SUBJECT: Forwards response to requests for addl info re structural review of expansion. Items addressed include steel column max compression load, analysis of floor & foundation slabs & load transfer. *SOB RPT*

H. B. ROBINSON STEAM ELECTRIC PLANT, UNIT NO. 2
DOCKET NO. 50-261
LICENSE NO. DPR-23
REQUEST FOR ADDITIONAL INFORMATION
CONCERNING SPENT FUEL POOL EXPANSION

H. B. ROBINSON STEAM ELECTRIC PLANT
RESPONSE TO NRC INFORMATION REQUEST

PLAN SHOWING FINAL
COLUMN LOCATION

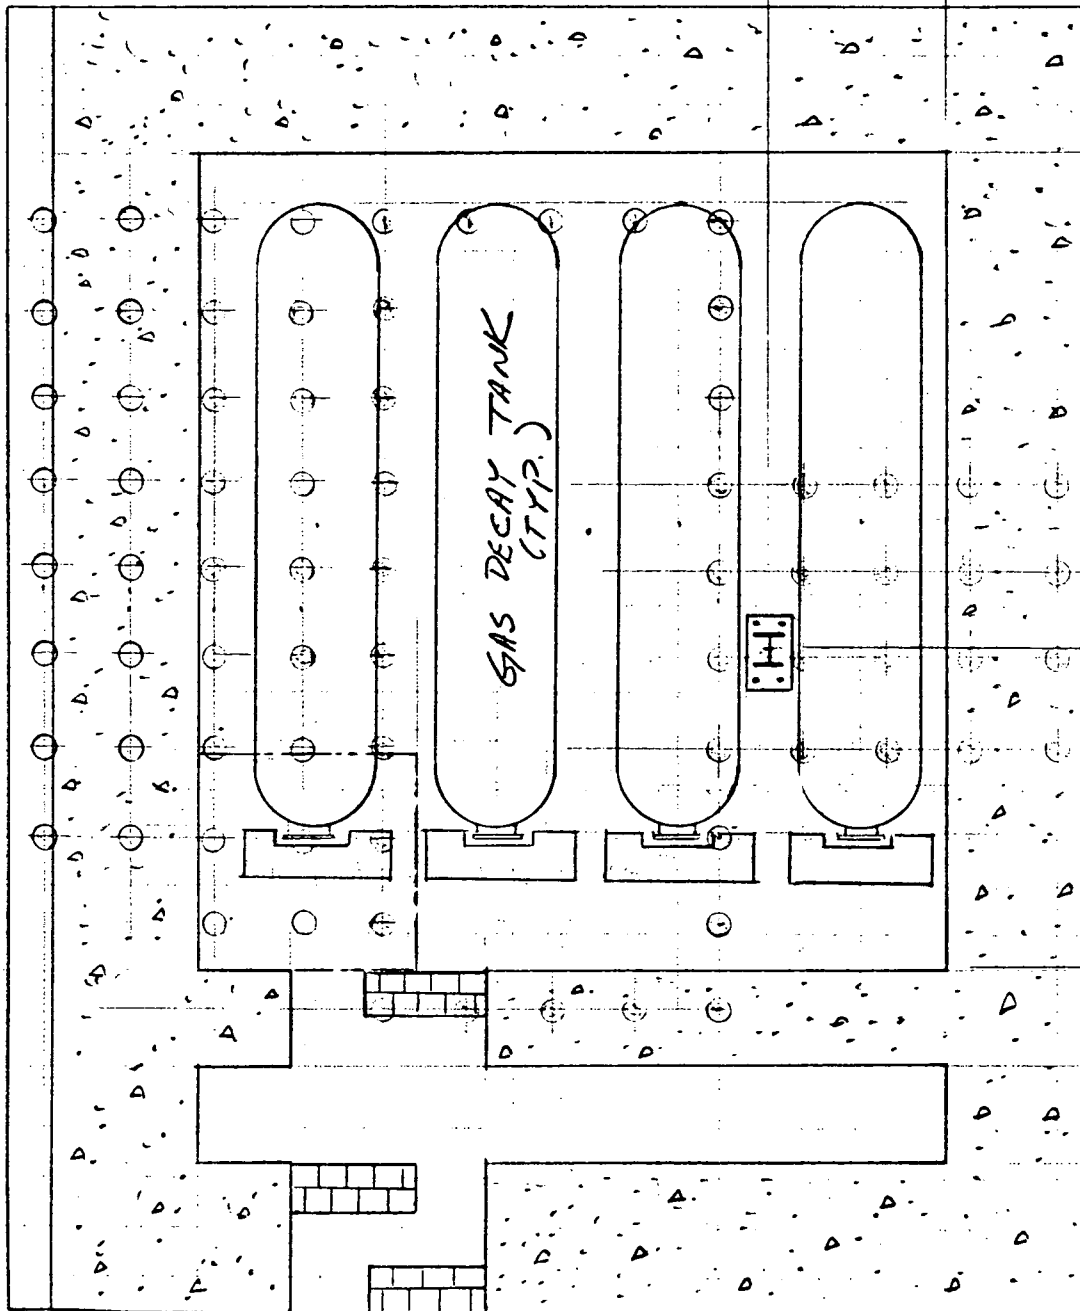
13. NRC Question

Where is the column located in relation to the piling?

Attached are two sheets, (Attachment 2, pages 18 and 180), detailing the location of the column in relation to the foundation pile cap. Also, see Attachment 4, which is a drawing of the "Fuel Handling Building Piling - Plans and Details", Ebasco drawing G-190419.

ATTACHMENT 3
H. B. ROBINSON UNIT NO. 2
SPENT FUEL POOL AREA
STRUCTURAL MODIFICATION
DRAWING CAR 2762-B-410-R1

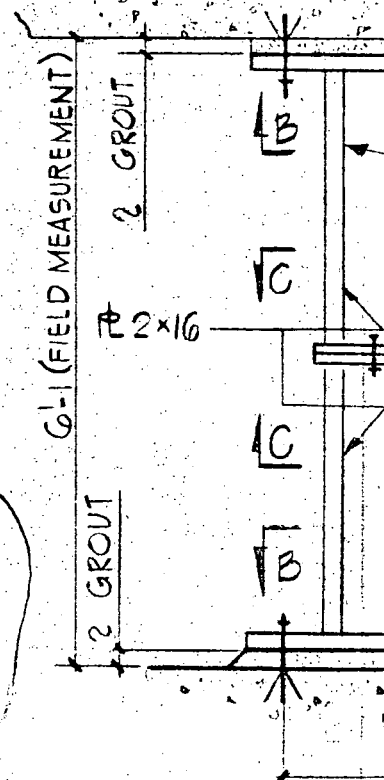
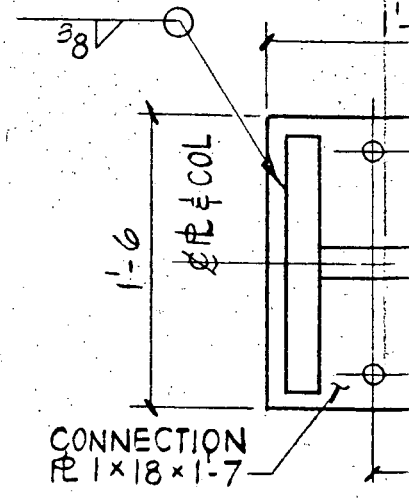
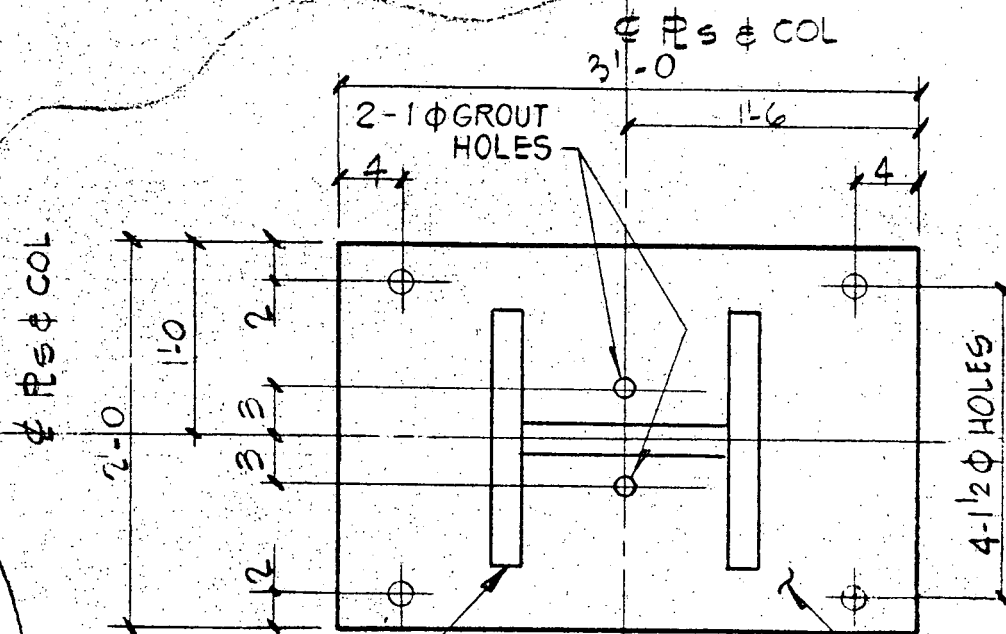
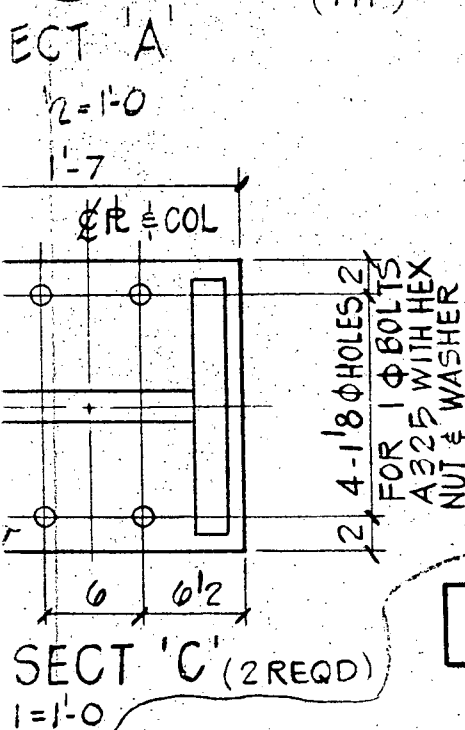
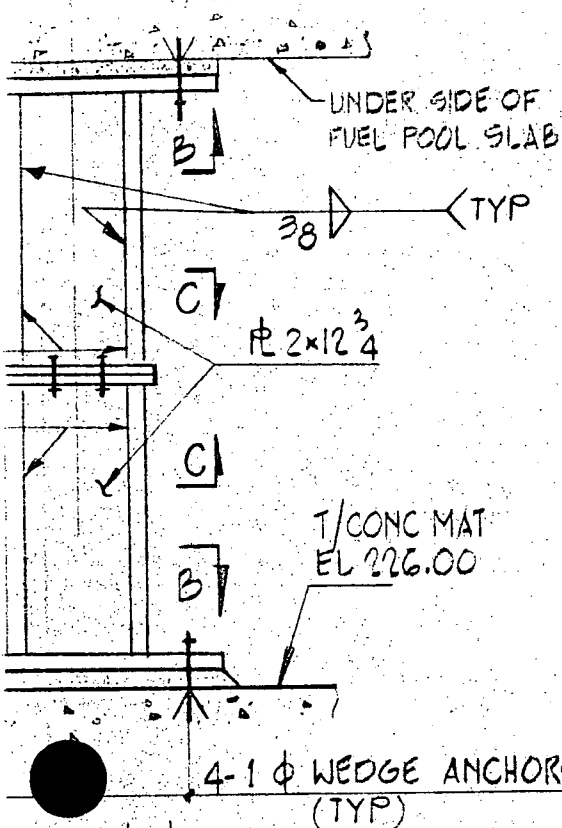
11. NRC Comment

Provide more information on the details of the connection of the column to the slabs and itself.

Details of column connections are shown on Drawing CAR 2762-B-410, Revision 1, dated December 4, 1981, (Attachment 3).
